From: Michael Behrendt
Sent: Wednesday, May 12, 2021 11:29 AM
Subject: Gerrish Drive - follow up question on drainage *

Subject: [External] Gerrish Drive - follow up question on drainage *

Subject: Gerrish Drive - question from James Bubar

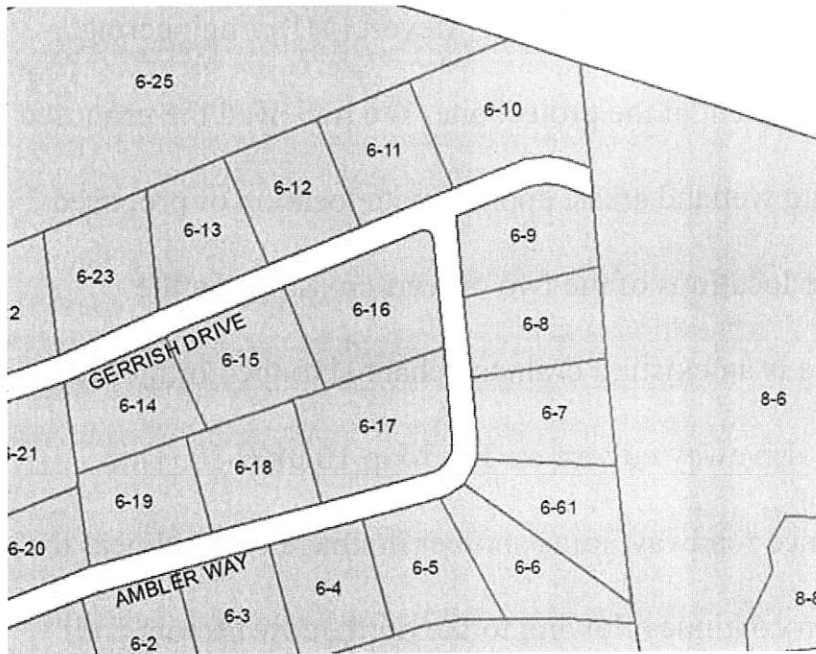
In your email below you ask about potential for flooding on neighboring lots along Gerrish Drive and Ambler Way. We specifically asked Mark Verostick, the Town's consultant with VHB, to address this for the nearest lots: 6-9 (White), 6-10 (Kelley), 6-11 (Lewis), and 6-16 (Sproul), as shown on the tax map below. He speaks to this issue in the excerpt from his report below (highlighted). Gail Kelley questioned the language he uses, "it does not appear that..." Since you have raised this question as well I will contact Mark Verostick now and ask him to clarify this matter.

Richard Reine (Durham Director of Public Works) and Mr. Mike Sievert (MJS Engineering, P.C.) to review the existing conditions and the proposed development at the project site. We reviewed the proposed roadway layout that had been previously staked out, existing wetland areas, approximate location of proposed stormwater features and spent some time looking at the locations of the two culvert crossings on the entrance roadway at approximate stations 1+75 and 4+10. There is an existing drainage channel to the north of the proposed roadway that allows runoff to flow from an existing driveway culvert on Tax Map 10 lot 6-10. This drainage channel is on the downstream side of the proposed entrance roadway, joins another drainage channel near the downstream end of a proposed roadway culvert and then continues flowing to the north, downstream and away from the proposed roadway. The proposed roadway does not appear to affect the flow of this channel because the road will be constructed upstream from this channel. There is another drainage channel that flows from the abutting property to the south (Tax Map 10 lot 6-9). A proposed 5-foot wide by 2-foot high concrete box culvert is proposed at the location where this existing drainage channel crosses the proposed roadway. Based on the culvert analysis provided to VHB, it appears this proposed culvert has been adequately sized to accommodate runoff from a 100-year design storm and maintain at least 1-foot of freeboard from the lowest point on the proposed entrance road. Therefore, based on my observations in the field and the information reviewed it does not appear that the project as proposed would result in any stormwater impacts on the adjacent upstream lots including Tax Map 10 Lots 6-9, 6-10, 6-11 and 6-16.

I'm happy to provide clarification. When I say "...it does not appear that...", I'm stating that my conclusions are based on the information I had available during my review and does not account for circumstances that are not presented, for example, if the plans change, or if the project isn't constructed in accordance with the plans and calculations I reviewed or if there are environmental factors such as beaver dams or issues with the abutters existing driveway culverts, etc. I can say that based on the information I reviewed, the project will not contribute to flooding issues to these abutters, but I do not want to mislead anyone by guaranteeing that there cannot be flooding issues in the future. I hope that helps to clarify my statement below.
